Building Permit Application

Amendment, Permit # B 16004872

I am requesting to amend Permit # B 16 00 48 72 at
WE WANT TO ADD A FINISHED BASEMENT to
THE SINGLE FAMILY DETACHED. THE HOUSE IS
CURRENTLY UNDER CONSTRUCTION AND WILL BE BUILT
OUT SIMULTANEOUSLY
REC ROOM, BATH, BEDROOM #3, EXERCISE + UNFINISHED
Rev #2 3/21/2017 B

I am requesting to amend Permit # B16004872 at
17245 HARDY ROAD MT. AIRY 21771 to
CONSTRUCT A DETACHED 2 CAR GARAGE
PER ATTACHED PLAN.

FINISHED BASEMENT PLAN

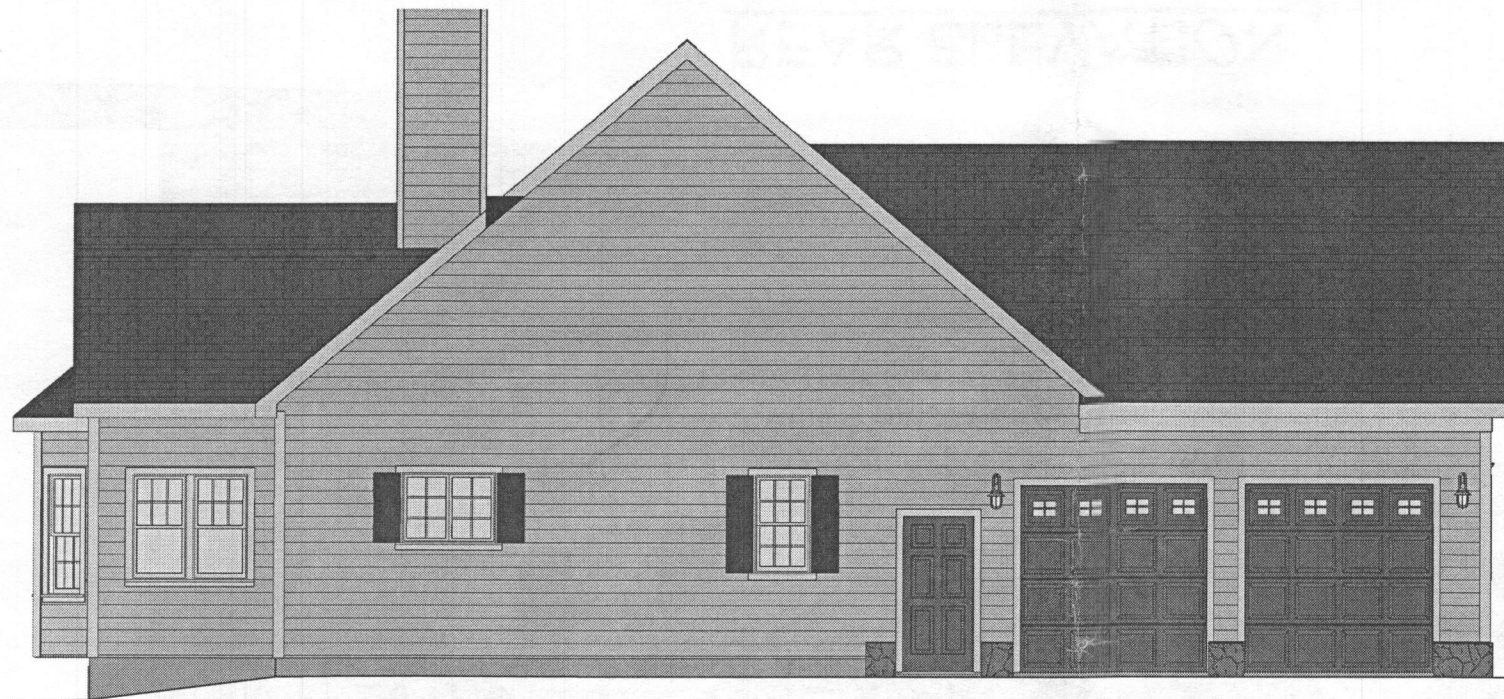
APPROVED
 WALK-THRU BUILDING PERMIT
 BP# 116004872 A# Amendment
 APP. SAN H. Oswald DATE: 3/2/17
 DESC. OF WORK: Finish basement
to include rec. room, bedroom
full bath & exercise room.

FIRST FLOOR PLAN

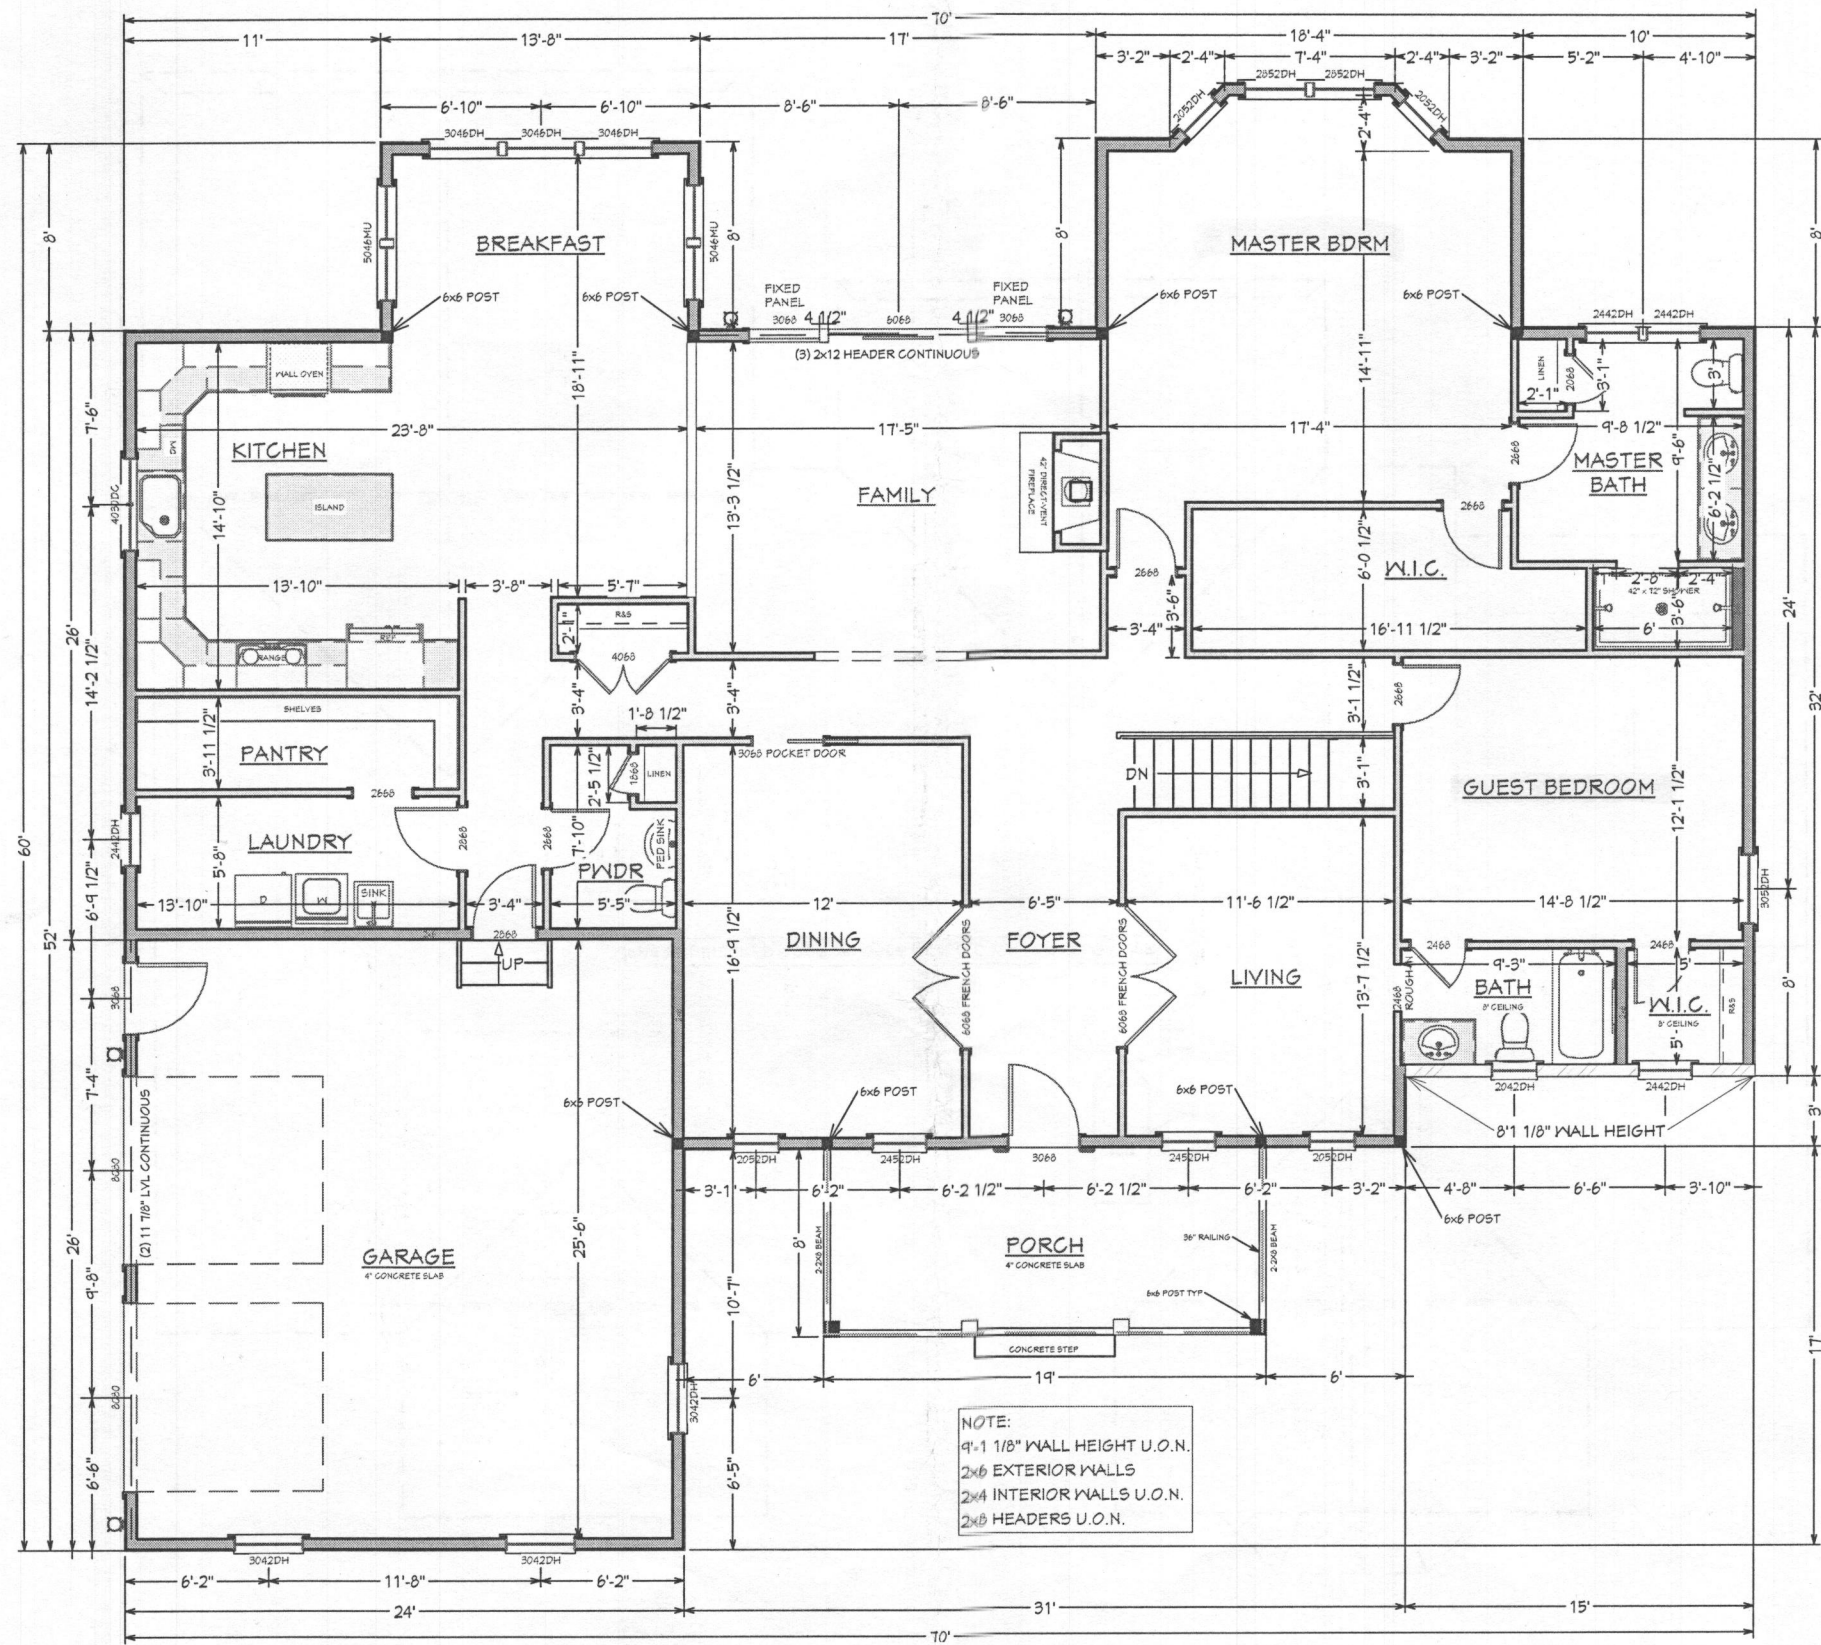
I have quick question about the floor plans for 17245 Hardy Road. Is there a second floor?

There is no 2nd floor
This is a ranch style home
